PIC16F627A/628A/648A Rev. A Silicon/Data Sheet Errata

The PIC16F627A/628A/648A parts you have received conform functionally to the Device Data Sheet (DS40044F), except for the anomalies described below.

FIGURE 1: BLOCK DIAGRAM OF RB1, RB2

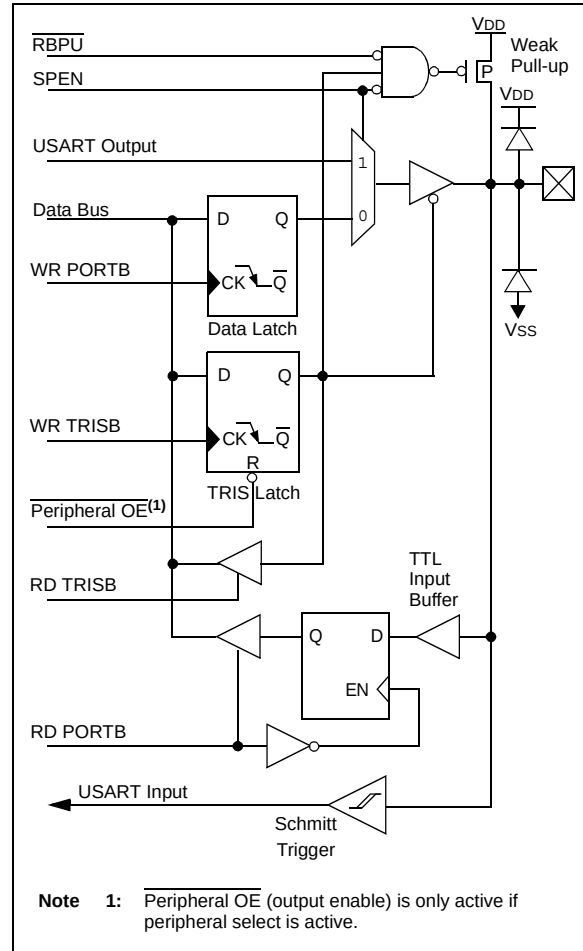
1. USART control of the RB1/RX/DT and RB2/TX/CK differs from the data sheet. Figure 5-9 and Figure 5-10 indicate that the USART circuit overrides the output drivers via the Peripheral OE signal. In fact, the Peripheral OE signal forces the TRISB<2:1> to an output (Reset) state (see Figure 1). Subsequently, the TRISB<2:1> must be set or configured to receive data.

In Asynchronous mode, when transmit is enabled (TXEN = 1 and SPEN = 1), the TRISB<2> latch is cleared to '0' by the USART peripheral circuitry. When disabling transmit (TXEN = 0), the TRISB<2> bit should be set to '1' to configure the RB2/TX/CK pin as an input.

In Synchronous mode, when changing from transmit to receive, clear the TXEN bit first, then set TRISB<1> to '1' to configure the RB1/RX/DT pin as an input before setting SREN or CREN to receive.

When disabling the USART (SPEN = 0), TRIS<2:1> should be reconfigured for input or output as required by the application.

FIGURE 14-18: TYPICAL IN-CIRCUIT SERIAL PROGRAMMING™ CONNECTION

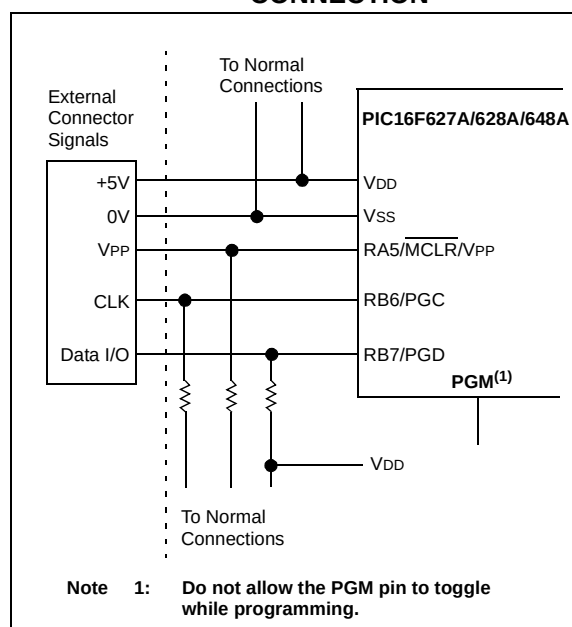
Section 14.11: In-Circuit Serial Programming and Figure 14-18: Typical In-Circuit Serial Programming Connection. The following paragraph and Note box are being added to the end of Section 14.11 and Figure 14-18 is updated to include PGM, noted in bold.

If LVP is not being used for programming, but the LVP Configuration bit is set (or LVP feature is enabled), the PGM pin must not be allowed to toggle while programming. The PGM pin is edge sensitive and if an edge is detected during programming, it may cause the PC to reset. If the LVP feature is disabled, the PGM pin will have no effect on programming.

Note: The LVP feature is enabled by default when the LVP Configuration bit is set.
